Access Compliance Report

Public Rights-of-Way

(Curb Ramps)

Intersection ID: 27872	Main Street: BALLANTYNE_COUNTRY_CLUB_DR	Cross Street: LETHCO_WY	Location: SE
ADA ID: B6B50C6A8DF6	Ramp Type: Perp	Initial Pass/Fail: Fail	Overall Compliance: No
Severity Score: 33.75			
Codes/Mitigation Info/Possible Solution		Field Measurements/Component Compliance

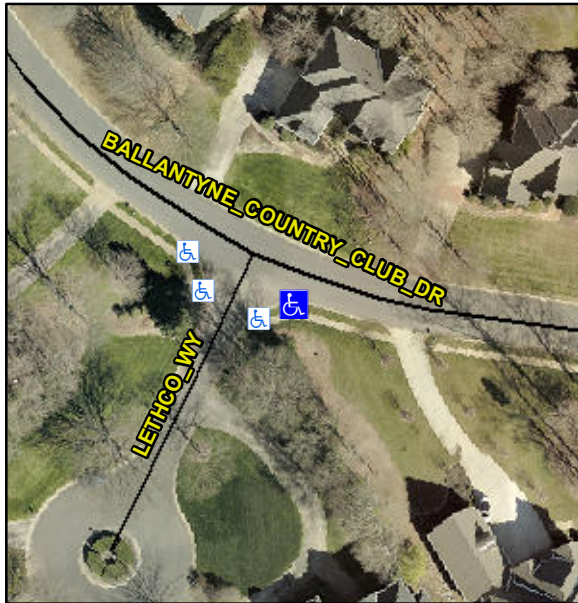
Not Found, R304.5.1, R304.5.3

Compliance	Description	Data	Compliance	Description	Data
N/A	Ramp Length (in)	48.0	Yes	Ramp Slope (%)	6.3
No	Ramp Width (in)	43.0	No	Ramp XSlope (%)	10.5
N/A	Flare Type LT	N/A	N/A	Flare Type RT	N/A
N/A	Flare Slope LT (%)	N/A	N/A	Flare Slope RT (%)	N/A
N/A	Flare Traversable LT?	N/A	N/A	Flare Traversable RT?	N/A
N/A	Landing Length (in)	N/A	N/A	DWS Provided?	N/A
N/A	Landing Width (in)	N/A	N/A	DWS Contrast?	N/A
N/A	Landing Slope (%)	N/A	N/A	DWS Length (in)	N/A
N/A	Landing X Slope (%)	N/A	N/A	DWS Full Width?	N/A
N/A	Landing Curb? (Y/N)	N/A	N/A	DWS Offset (in)	N/A
N/A	Shared Landing?	N/A			
N/A	Gutter Ponding?	N/A	N/A	Gutter Slope (%)	N/A
N/A	Gutter Lip Ht (in)	N/A	N/A	Gutter X Slope (%)	N/A
N/A	Painted X Walk1?	No	N/A	Painted X Walk2?	N/A
	X Walk 1 Direction	To NE		X Walk 2 Direction	N/A
N/A	X Walk 1 Width (in)	N/A	N/A	X Walk 2 Width (in)	N/A
	X Walk 1 Slope (%)	4.0		X Walk 2 Slope (%)	N/A
	X Walk 1 X Slope (%)	10.2		X Walk 2 X Slope (%)	N/A

Remove & Replace Entire Ramp.
